PLANNING ALTERATIONS
LEVEL 02

Stage 1a - Level 2

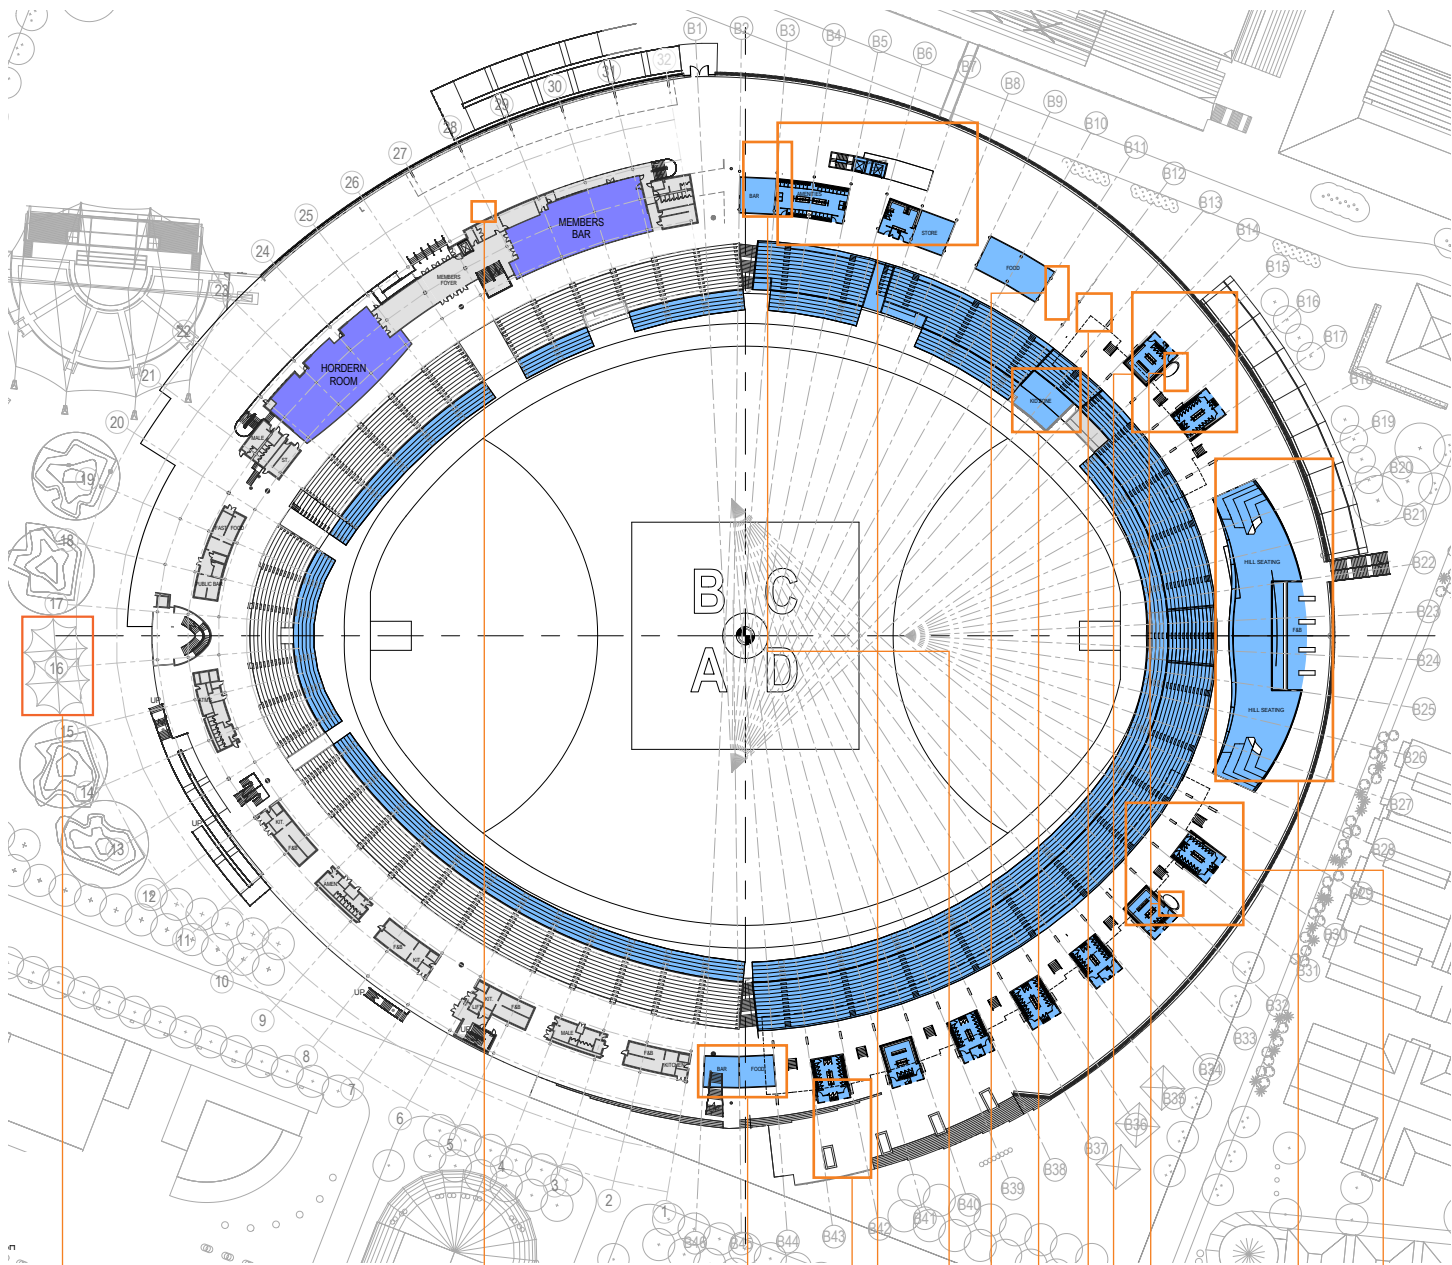
1. Existing conditions of spaces retained in favour of refurbishment
2. Relocation of Asset Management beside Field Access Vomitory 3
3. Relocation of Sign Workshop next to Plumbing Workshop
4. Removal of Field Club Lounge
5. Expansion of kitchen into adjacent Showring Maintenance Store
6. Relocation of Cleaners Store, General Store and Gardeners Store under external access ramp
7. Relocation of Electrical & Gardener Workshop
8. Addition of OB Compound
9. Removal of field access stairs on the NW and SE centre line
10. Reconfigured Interchange Benches and removal of temporary GA seating from NW bowl
11. Removal of Kidzone
12. Addition of external space outside Field Ops building during AFL matches

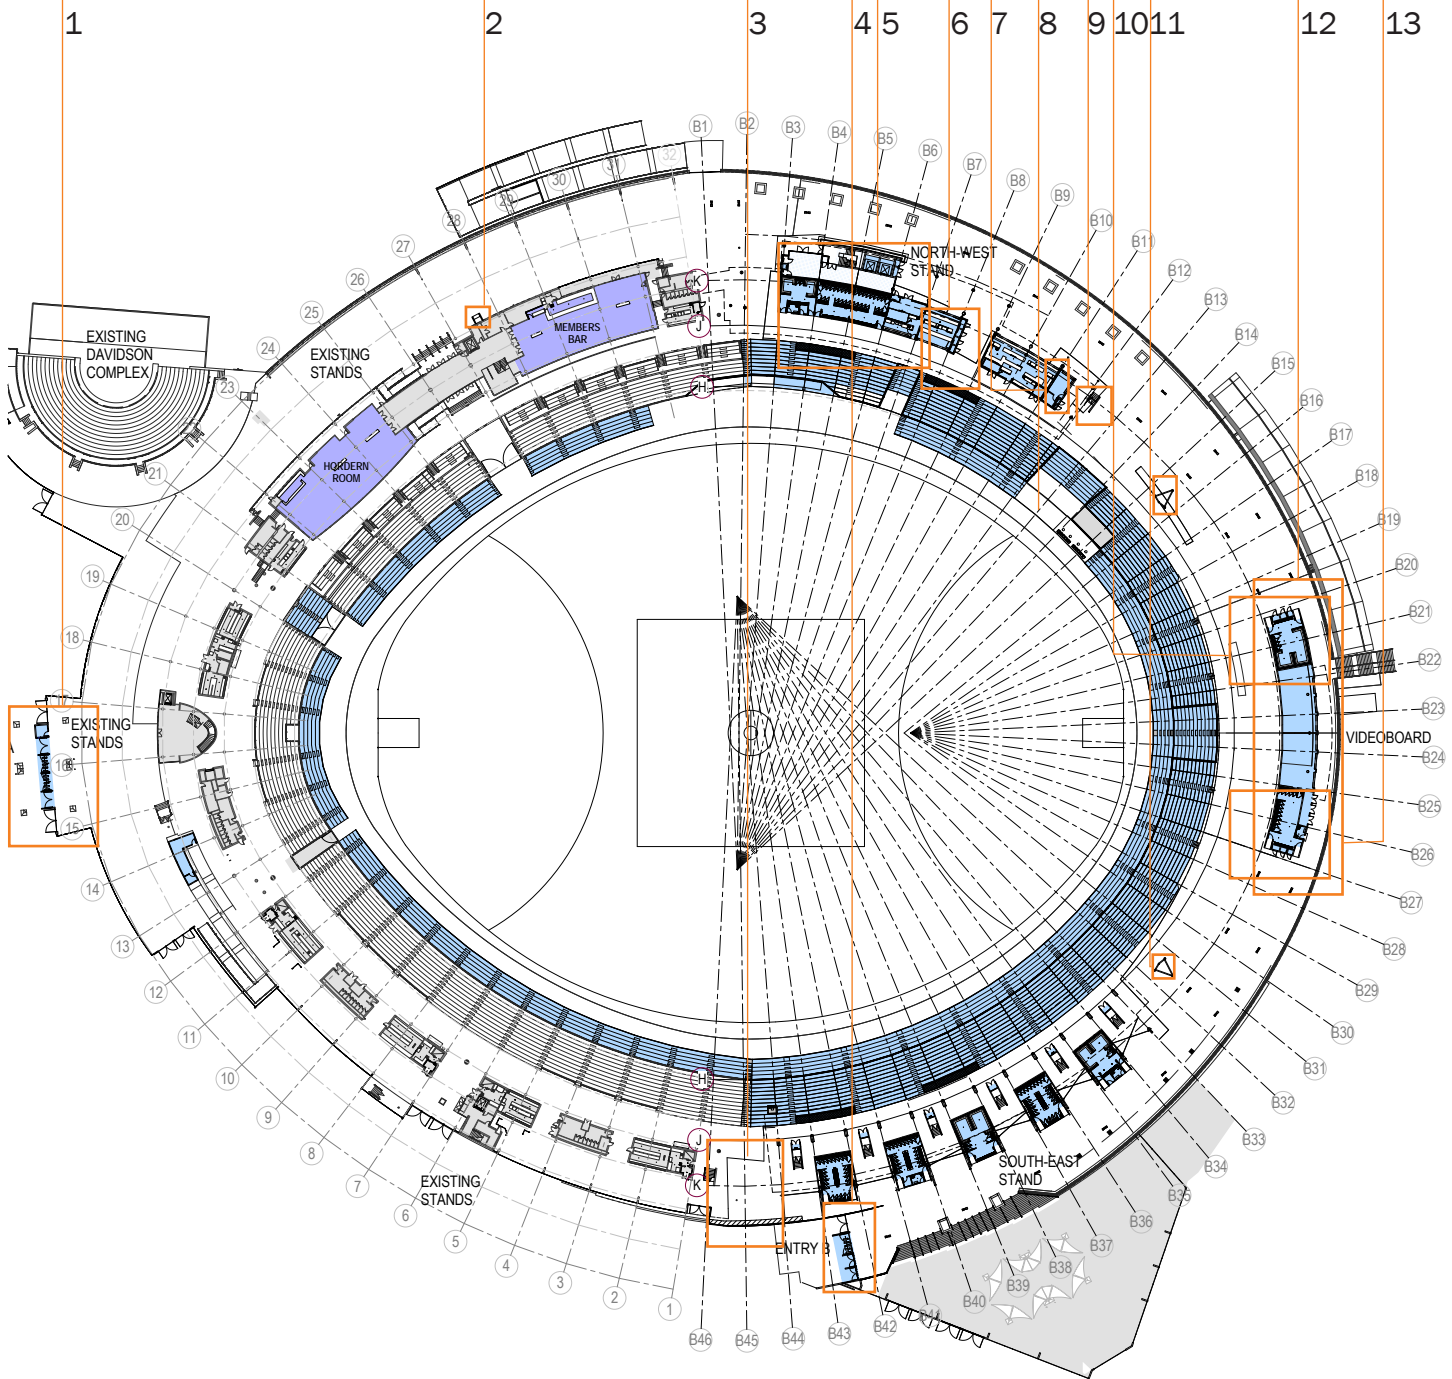
1. Addition of entry portal for Gate A under existing shade structure adjacent to Presidents Plaza
2. Addition of L1 kitchen exhaust duct penetration through L2 Concourse
3. Removal of SE F&B
4. Addition of entry portal for Gate B
5. Consolidated NW amenity to close off rear wall for the corporate entry lobby
6. NW Bar consolidated with remaining NW F&B
7. Addition of Merchandise Store to F&B on northern concourse
8. Removal of Kidzone from lower bowl
9. Addition of egress stair to northern end of Corporate Stand
10. Relocation of two NW amenity blocks next to F&B under Video Board
11. Relocation of light towers closer to field
12. Removal of hill seating area - F&B shell retained for bump-in use
13. Relocation of two NE amenity blocks next to F&B under video board

Stage 1a - Level 3

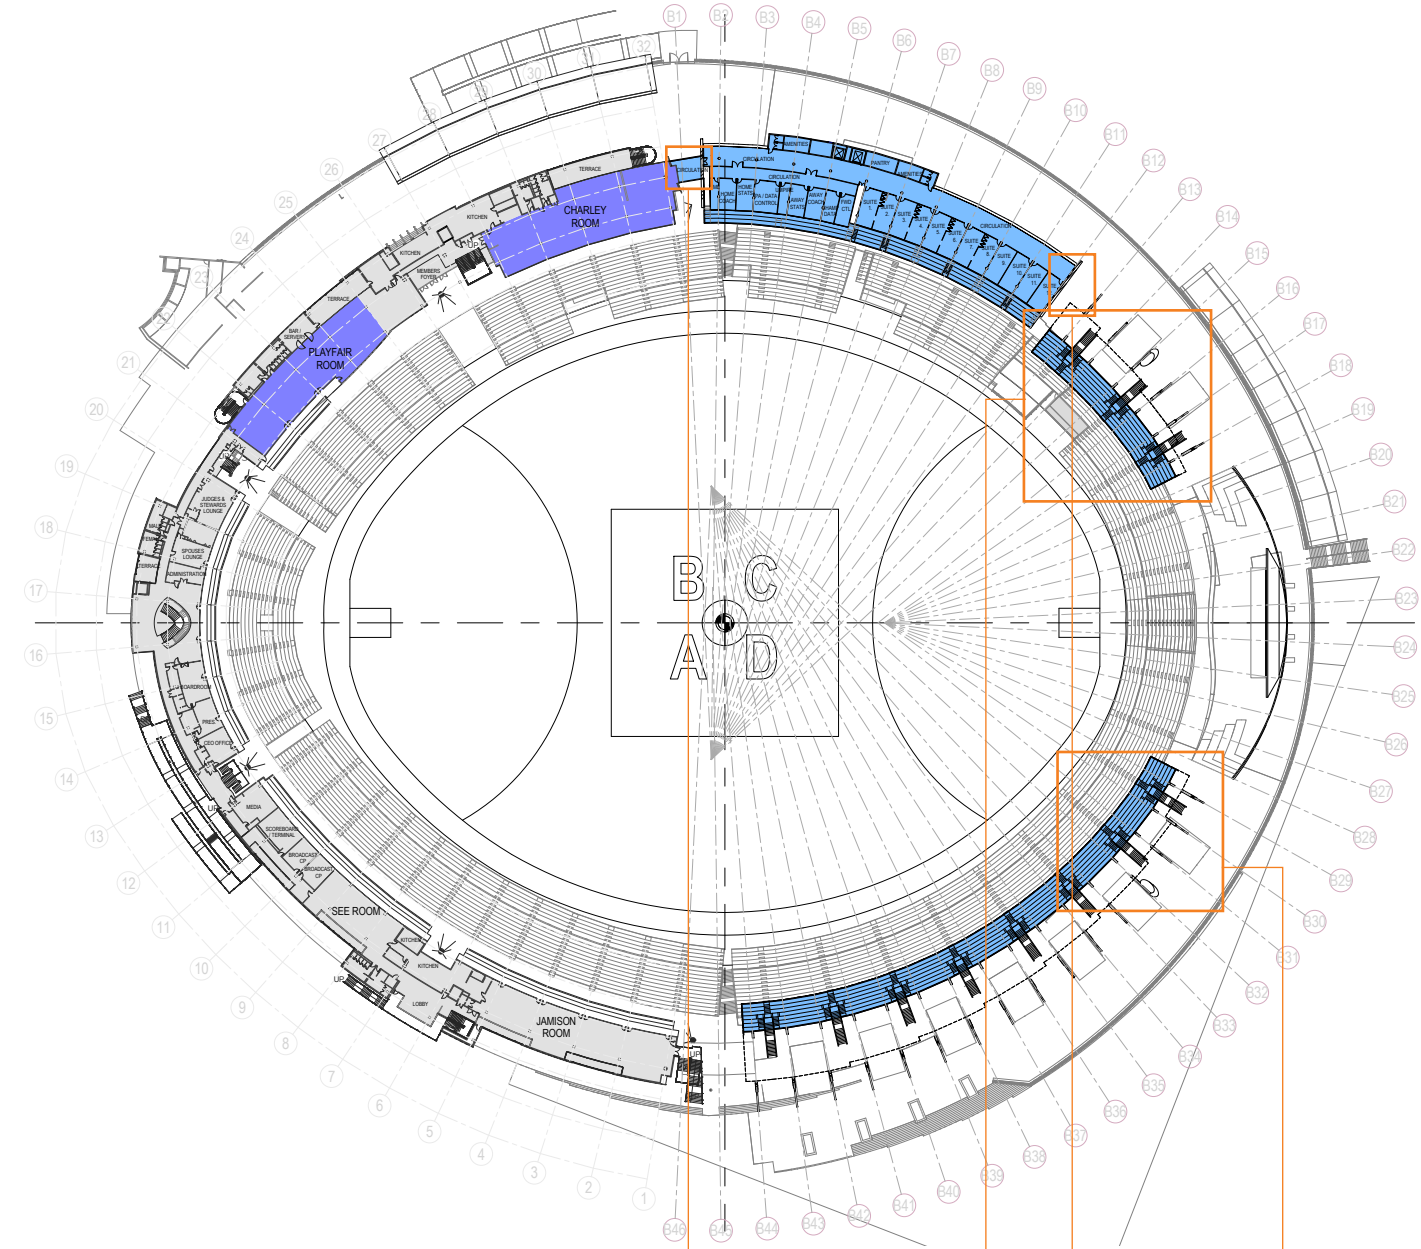
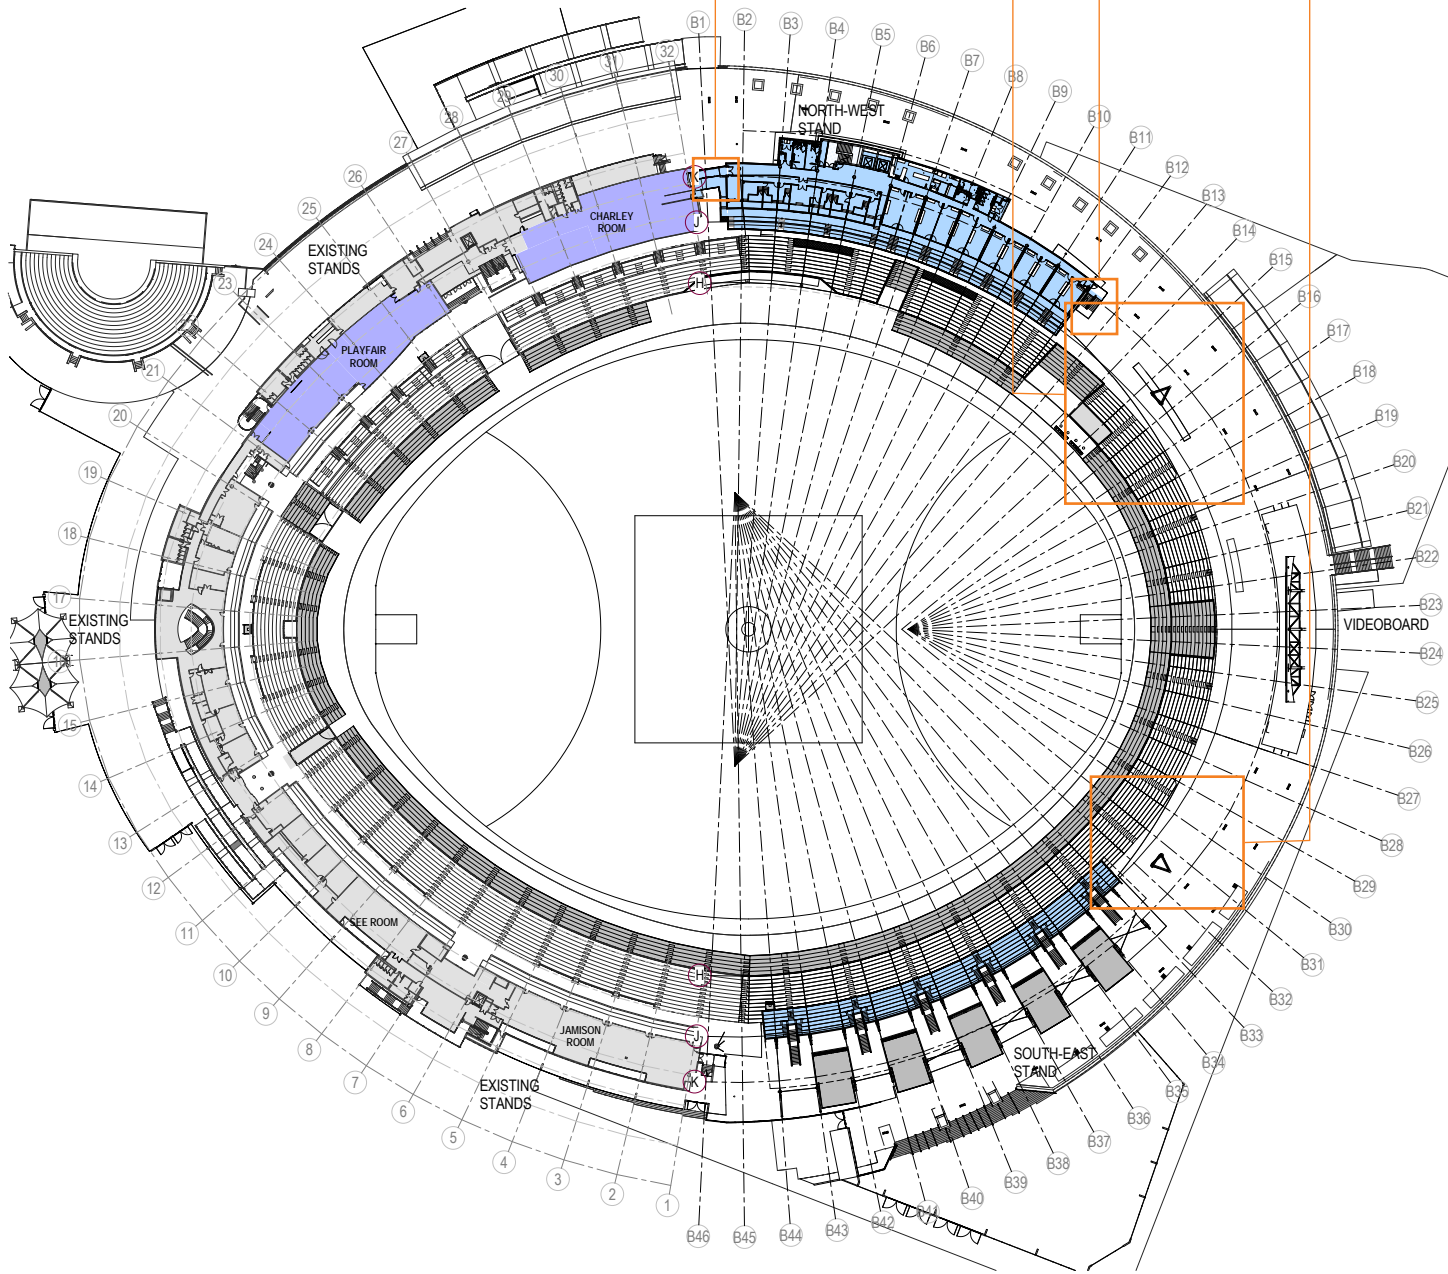
- 1. Redesign of Charlie Room link as open bridge
- 2. Removal of NW upper tier GA grandstand
- 3. Addition of egress stair to northern end of Corporate Stand
- 4. Removal of two bays from SE upper tier grandstand

Stage 1a - Roof

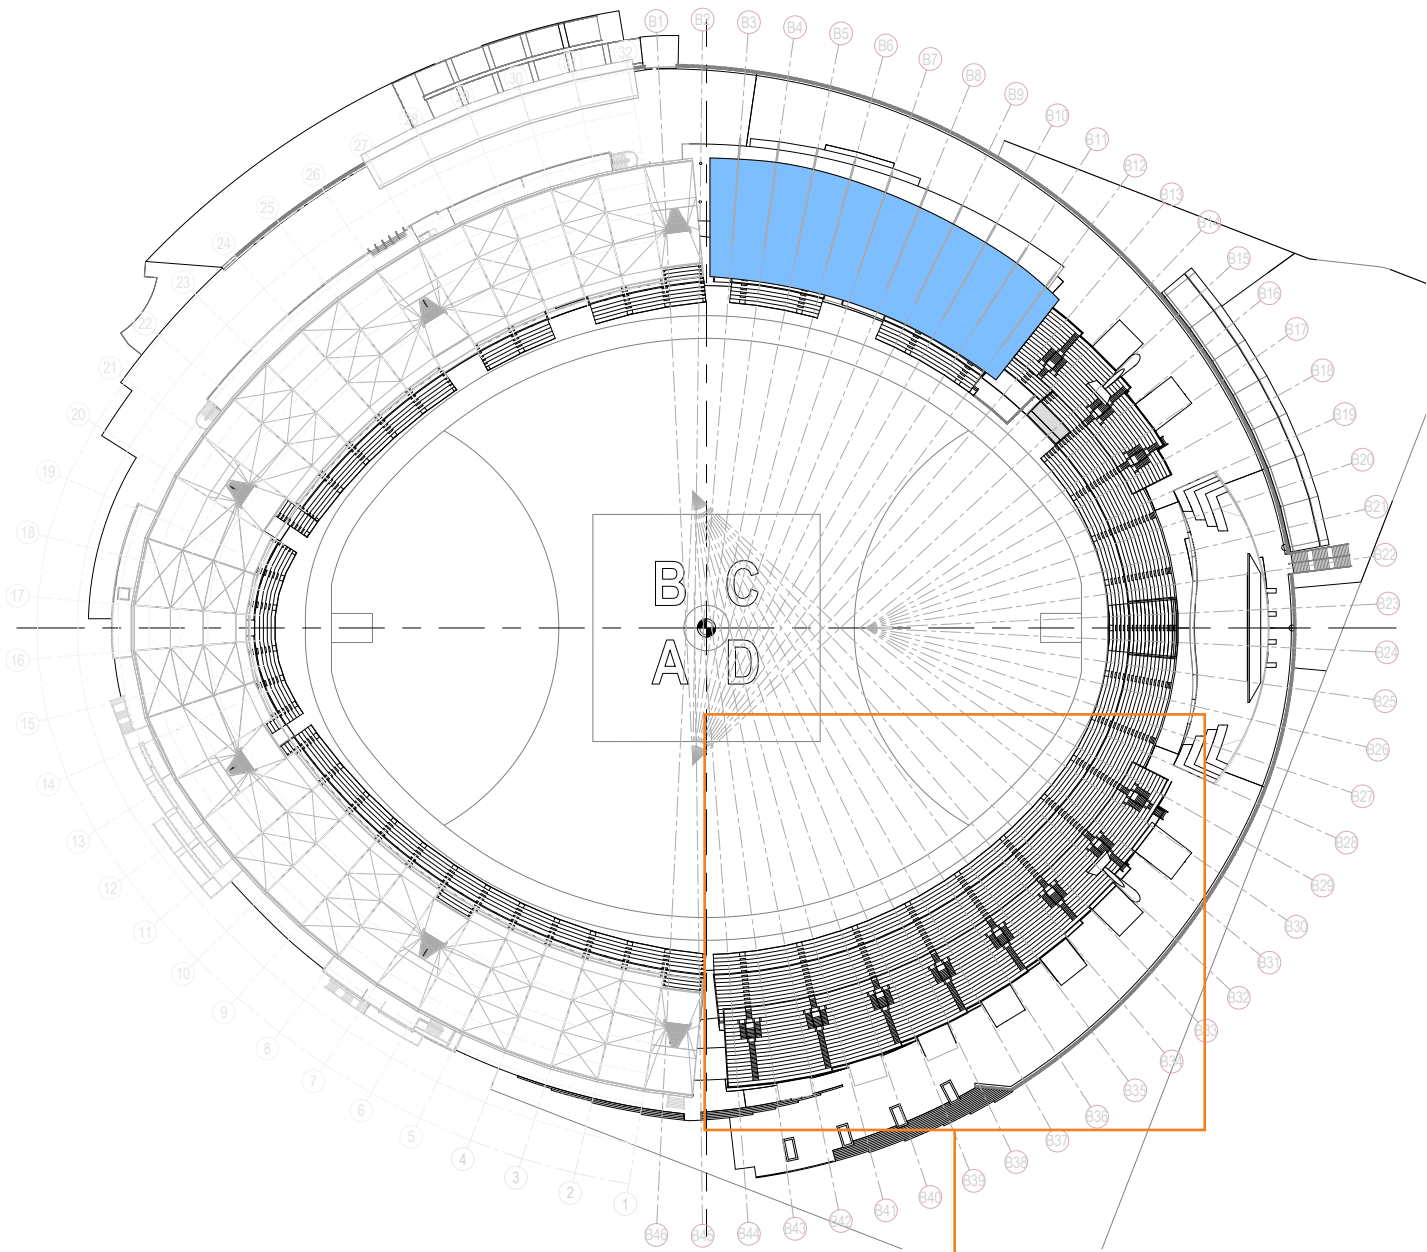
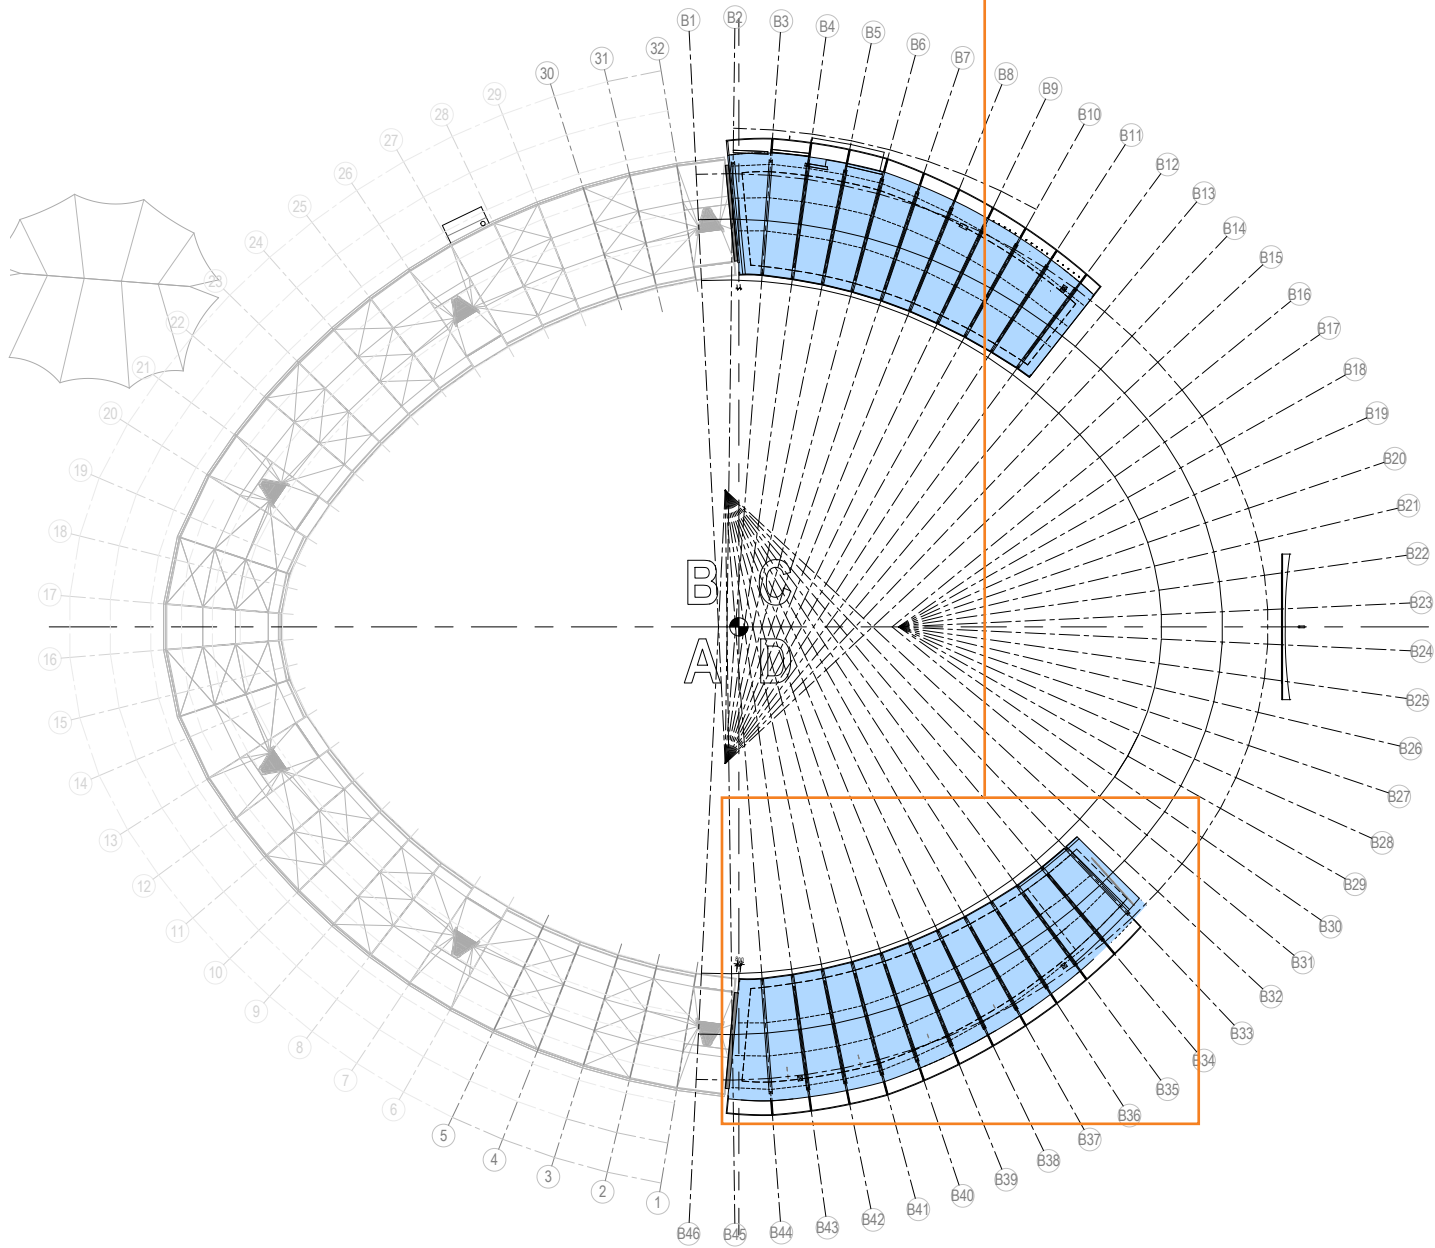
1. Addition of roof over permanent SE upper tier
GA seating
